Docket Items #5 & 6
BAR #2018-00412 & 2018-00413

BAR Meeting
October 3, 2018

ISSUE: Re-Approval of Permit to Demolish/Capsulate and Certificate of Appropriateness for alterations

LOCATION: 420 South Pitt Street

SOUTH ELEVATION (SIDE ELEVATION)
 1/4" = 1'-0"

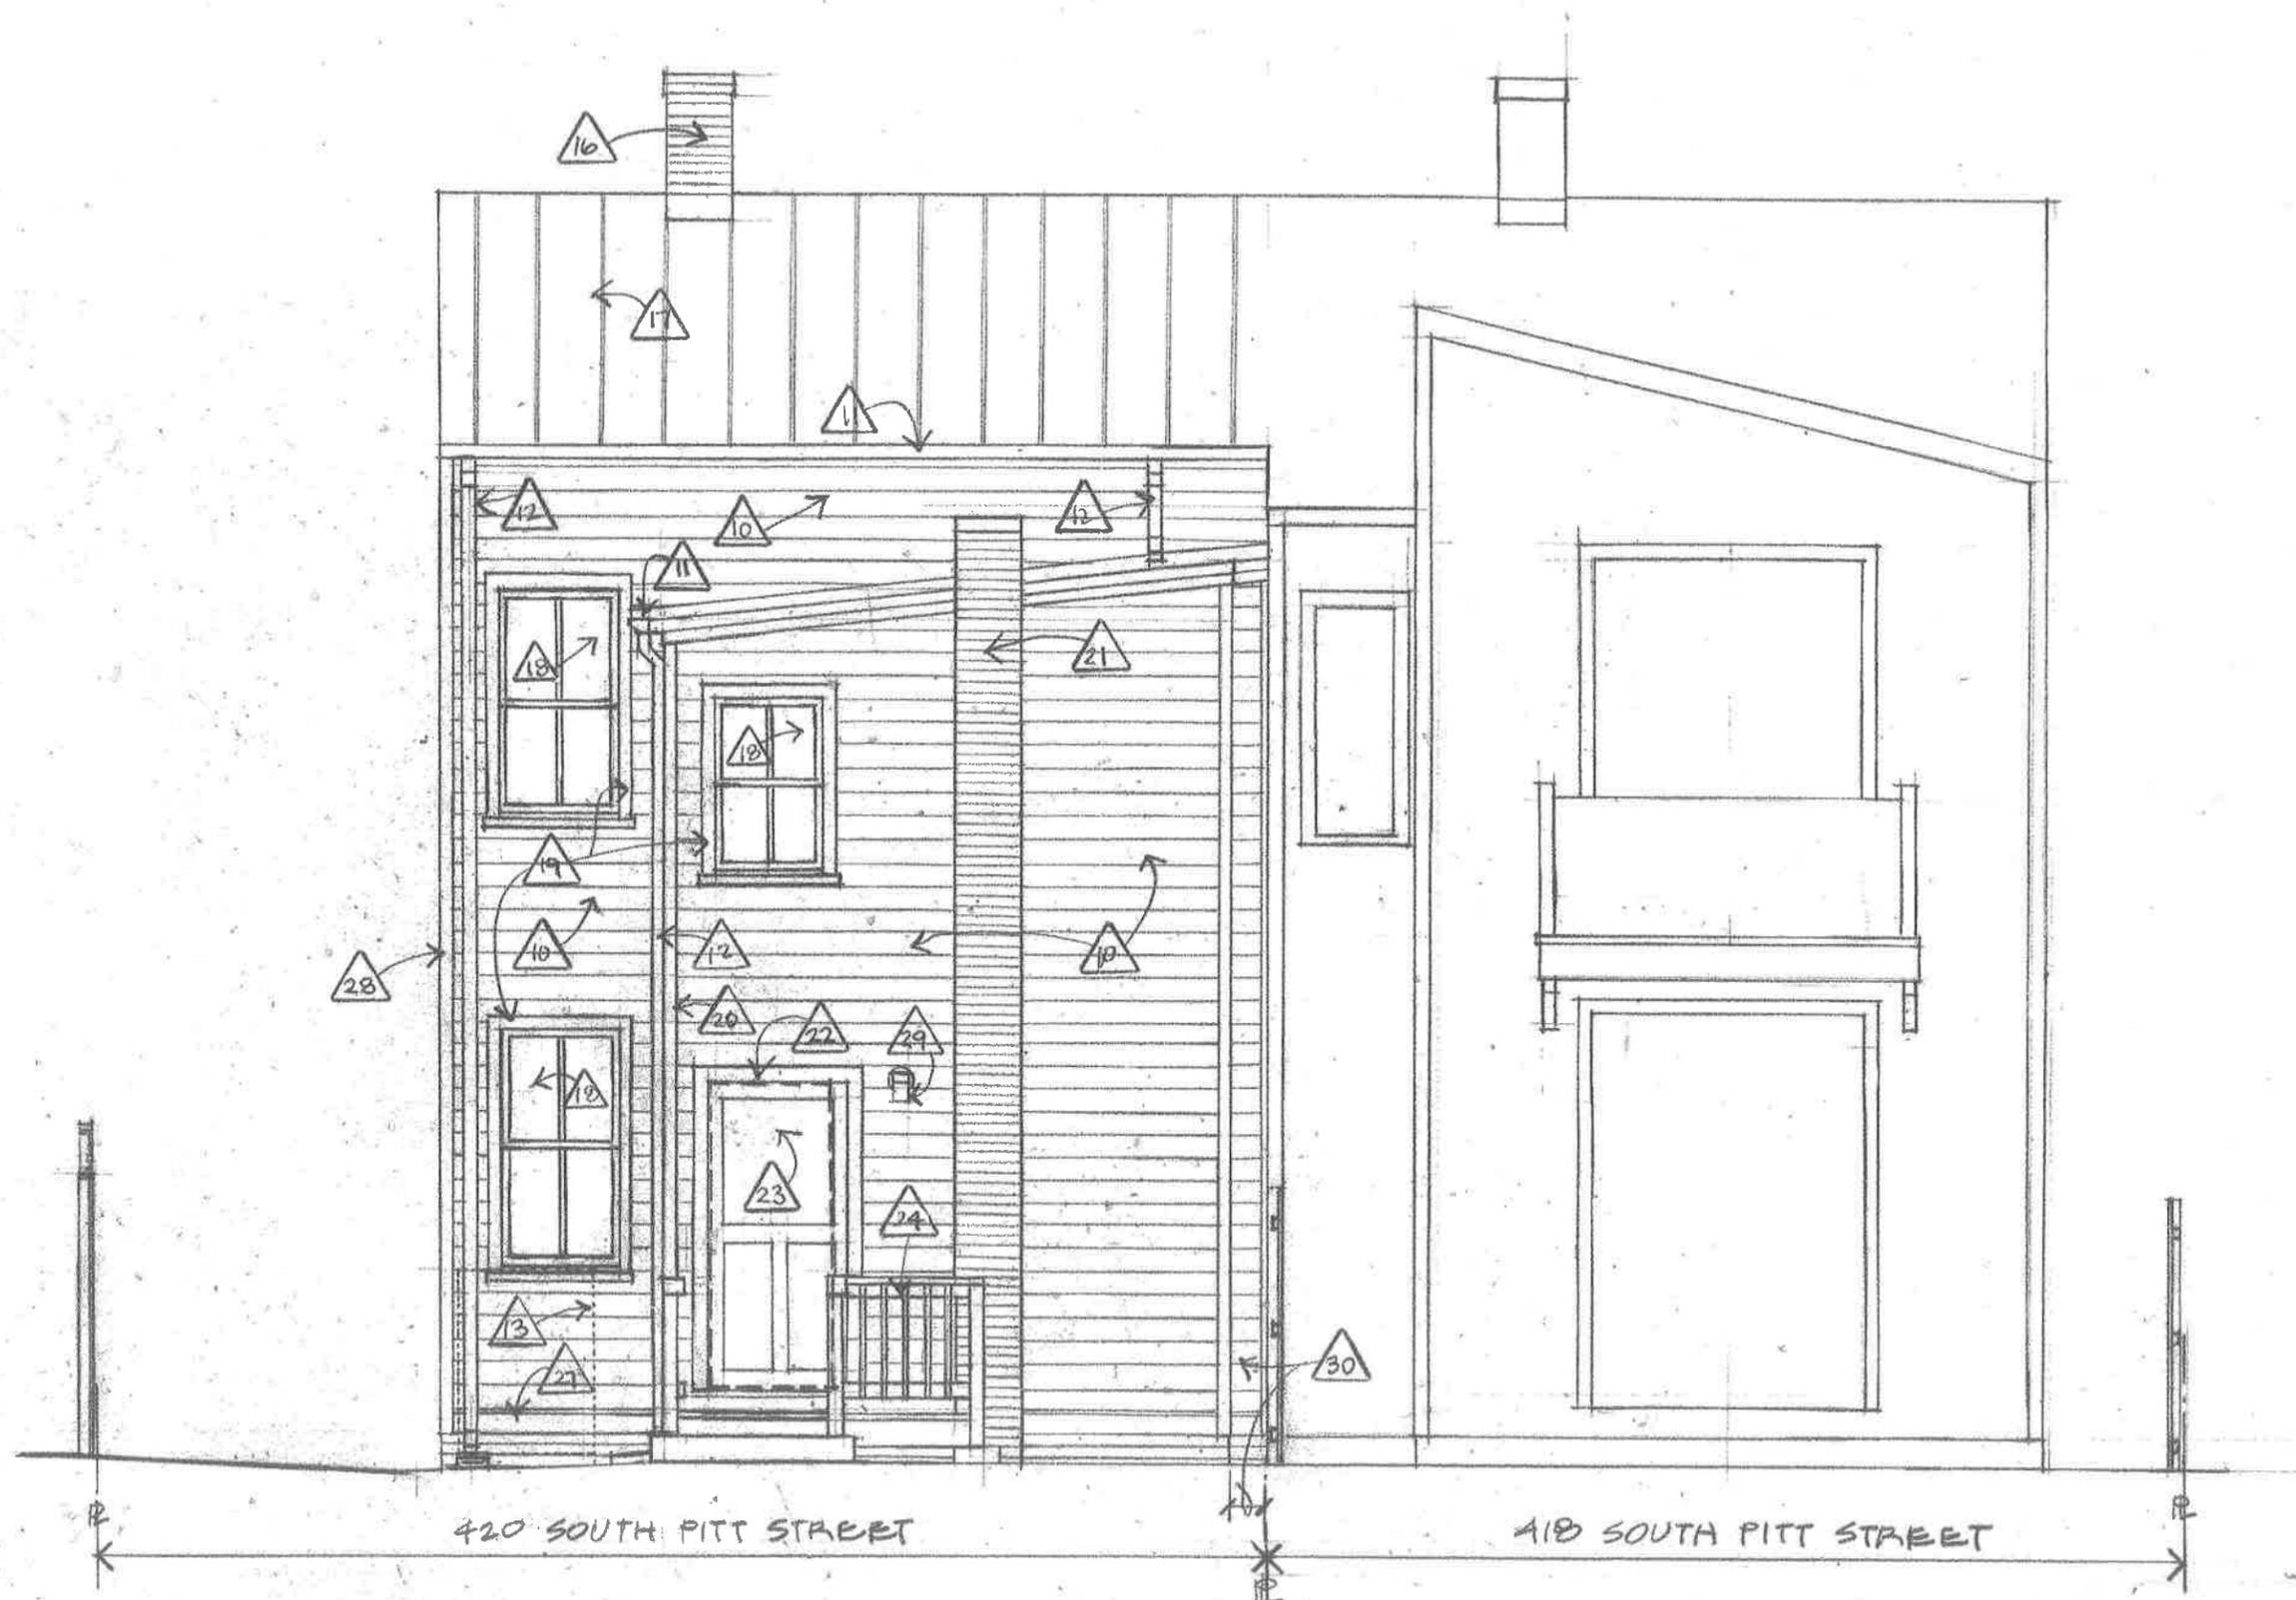
Demolition is limited to the removal of an existing door opening on the south elevation of the rear ell.

The amount of demolition is limited to just over 25 square feet for the removal of a door opening on the south elevation of the ell which is not visible from the right-of-way. The door has no remarkable or unusual features or materials, nor exceptional craftsmanship and it could easily be reproduced in the future, should anyone desire to do so. Further, the removal of one of two doors on the modest rear ell will allow for a more efficient interior layout. Therefore, staff recommends approval of the Permit to Demolish.
